UNITED STATES
NUCLEAR REGULATORY COMMISSION
WASHINGTON, D. C. 20555

Docket No. 50-29

RE: ENVIRONMENTAL QUALIFICATION OF ELECTRICAL EQUIPMENT

FIGURE 1

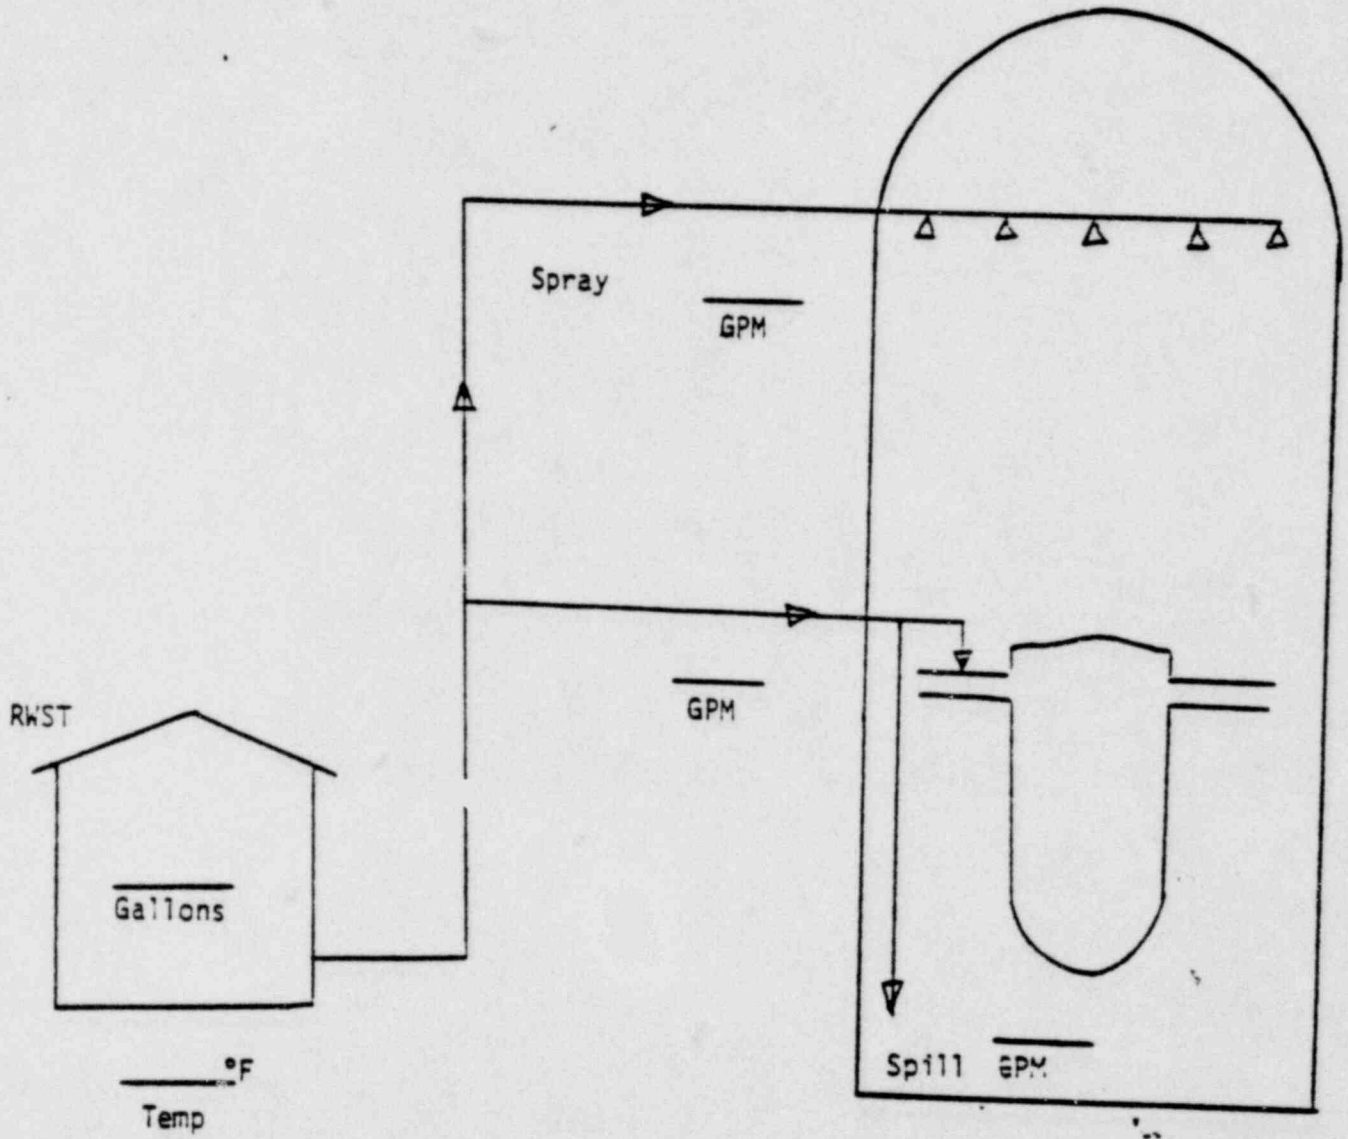
II. Figure 1 and 2 represent typical ECCS and spray systems relied on to mitigate the consequences of a pipe break. Provide the information indicated in the figures; if the plant specific systems differ from the attached figures, revise the drawings to represent your facility and provide the appropriate information.

When providing system parameters, indicate whether the values given assume a single failure and specify the single failure assumption.

FIGURE 1 - INJECTION PHASE

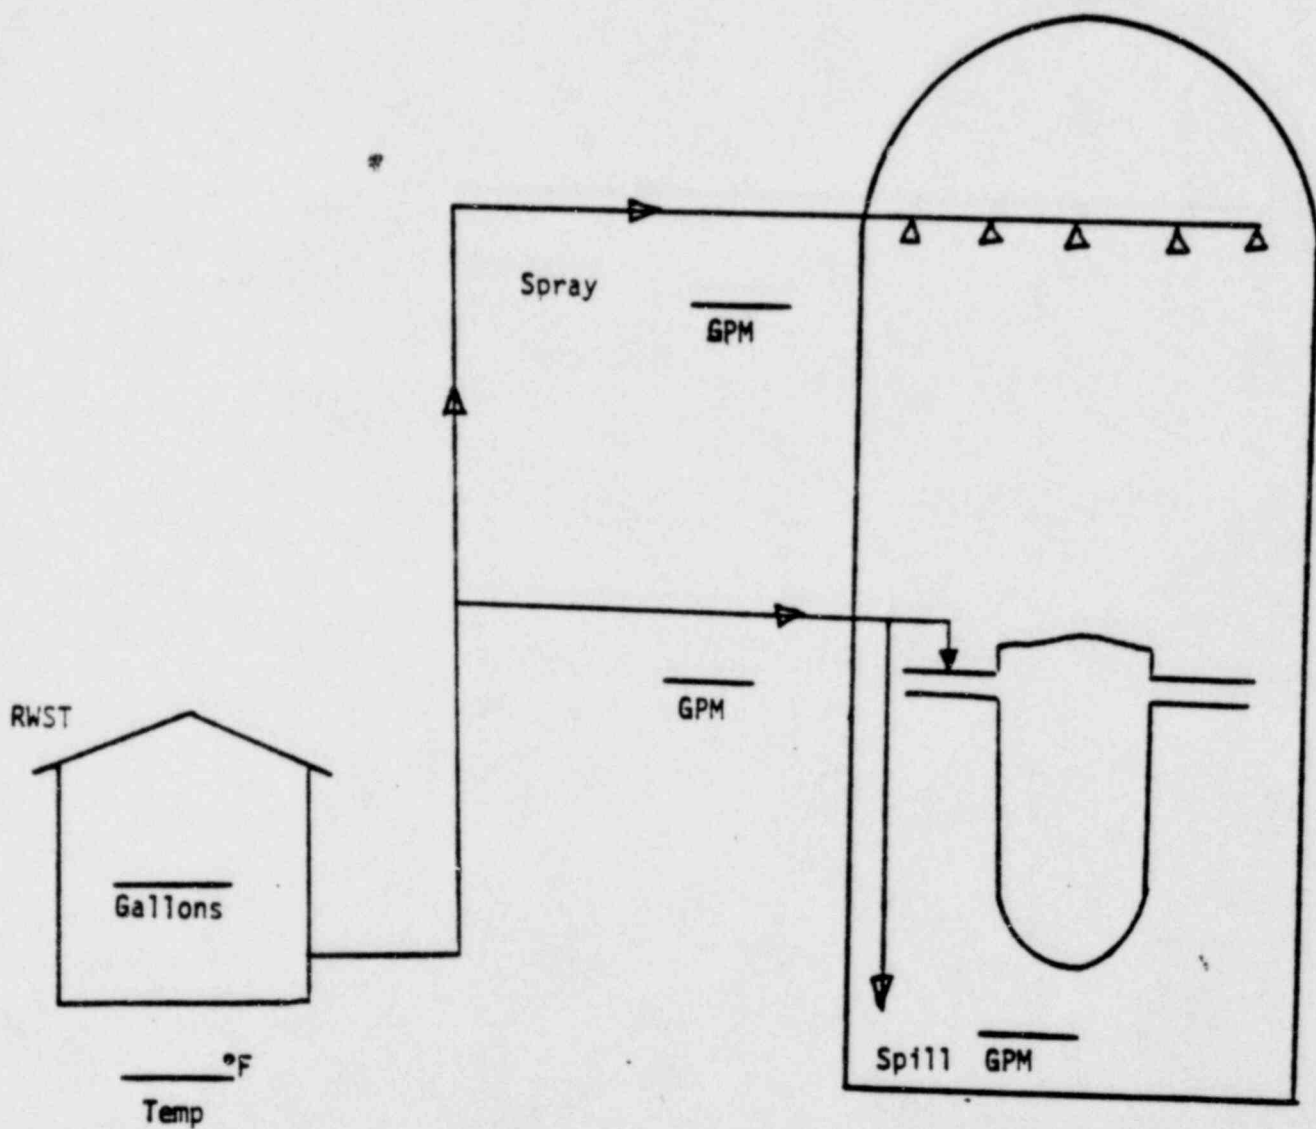
When providing system parameters, indicate whether the values given assume a single failure and specify the single failure assumption.

Figures 1 and 2 represent typical ECCS and spray systems relied on to mitigate the consequences of a pipe break. Provide the information indicated in the figures, if the plant specific systems differ from the attached figures, revise the drawings to represent your facility and provide the appropriate information.
